Addendum No. 1
for Construction of
Water Pump Station
for the
CAGLE-FREDONIA UTILITY DISTRICT
in
SEQUATCHIE COUNTY, TENNESSEE

CONTRACT 125 – WATER PUMP STATION – JOHN HENRY LEWIS ROAD

Date: July 15, 2025
Bid Date: July 24, 2025
Bid Time: 2:00 P.M. LOCAL TIME

PLAN AND SECTIONS
JOHN HENRY LEWIS RD.
PUMP STATION

A. Pressure Gauges

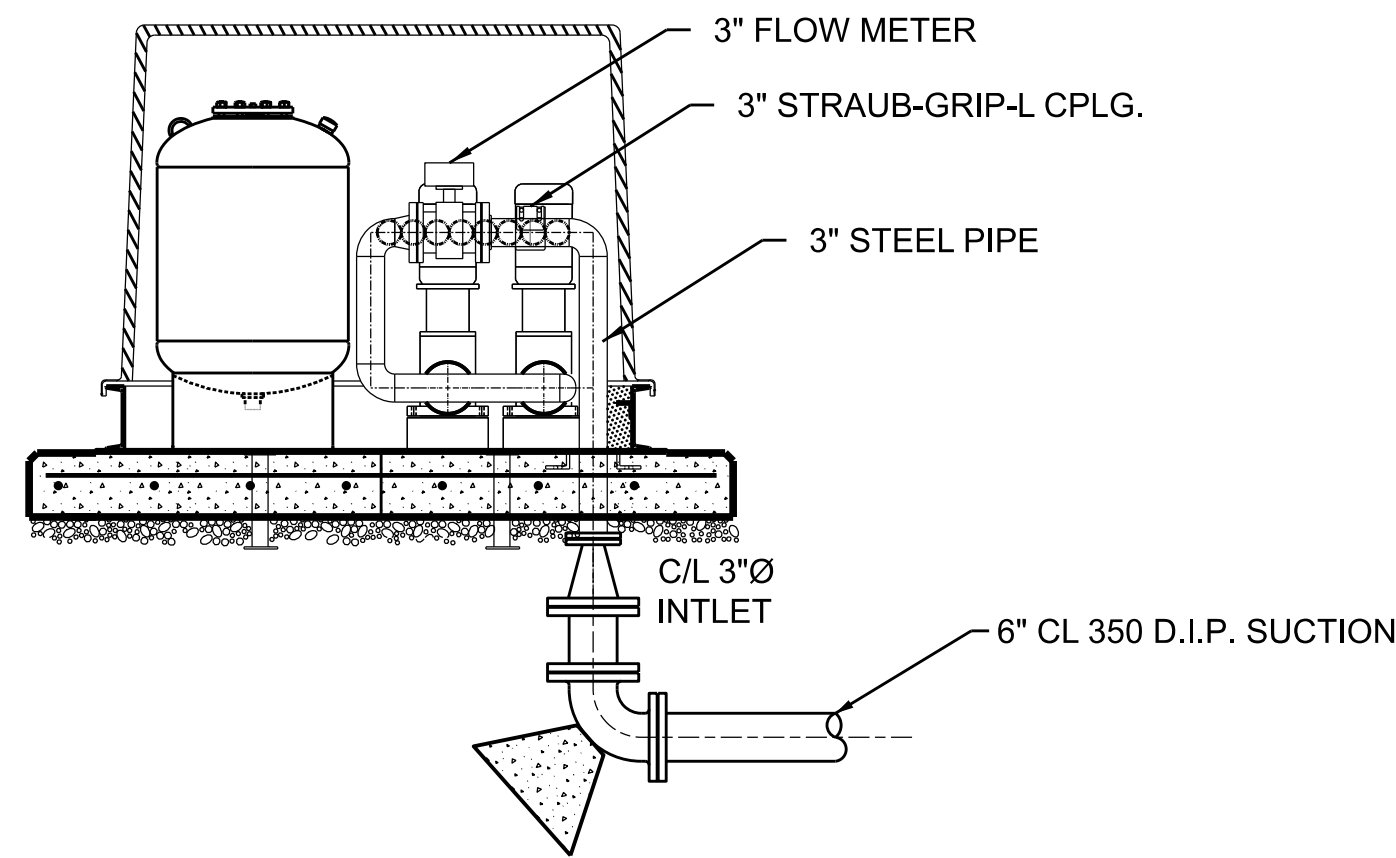
PLANS: Replace Sheet 3 with attached Sheet 3, the following items have been updated:

- General Note 5.
- Design Criteria - “Controls”.
- Revised note for “panel mounting” on Interior Plan View.

- STATION PIPING: INTERIOR STATION PIPING TO BE SCHEDULE 40 STEEL. ALL PIPE TO HAVE HEAT TRACE TAPE.
- STRUCTURAL STEEL: STRUCTURAL STEEL SHALL MEET ASTM A-36. STRUCTURAL TUBING SHALL MEET ASTM A500, GRADE B.
- PAINTING: CAPSULE AND STRUCTURAL STEEL SHALL BE PAINTED WITH 6MILS DFT OF TNEDEC SERIES N69. SURFACE PREPARATION SHALL BE IN ACCORDANCE WITH MANUFACTURER'S RECOMMENDATIONS. INSIDE OF STEEL PIPE TO BE TRIPLE FUSION COATED.
- DO NOT SHIM STATION. CONCRETE SLAB TO BE CONSTRUCTED LEVEL ON FIRMLY COMPACTED BASE MATERIAL.
- PRESSURE GAUGES: EACH PUMP SHALL HAVE A STANDARD PRESSURE GAUGE ON ITS DISCHARGE LINE AND A COMPOUND GAUGE ON ITS SUCTION LINE. GAUGES SHALL READ AS FOLLOWS:

SUCTION - 0 - 30 in. Hg / 0-160 psi
DISCHARGE - 0 - 200 psi
- TELEMETRY: CELLULAR TELEMETRY TO BE AS MANUFACTURED BY MISSION COMMUNICATIONS. TELEMETRY SHALL BE COMPATIBLE WITH THE OWNER'S EXISTING MISSION SYSTEM FOR MONITORING OF THE PUMP STATION.
- ALL EXTERIOR 6" PIPE SHALL BE PRESSURE CLASS 350 DUCTILE IRON WITH MECHANICAL JOINT DUCTILE IRON COMPACT FITTINGS. FITTINGS BELOW THE STATION SHALL BE RESTRAINED. PIPING UNDER STATION SHALL BE BACKFILLED WITH COMPACTED CRUSHED STONE.
- CONTRACTOR SHALL DISPOSE OF ALL EXCESS MATERIAL AND SITE CLEARING DEBRIS OFF-SITE.
- CONCRETE FOR SLAB SHALL BE 6.5 BAG MIX, MAXIMUM SLUMP OF 5.0 INCHES, 28-DAY MINIMUM STRENGTH OF 4,500 PSI. REBAR SHALL BE ASTM A 615 GRADE 60.
- INSTALL PUMP STATION AND EQUIPMENT PER MANUFACTURER'S RECOMMENDATIONS. PUMP STATION TO BE AS MANUFACTURED BY USEMCO, INC. TOMAH, WI OR PRE-APPROVED EQUAL.

CONTROLS: CELLULAR TELEMETRY, VFD's, ALTERNATING PUMPS
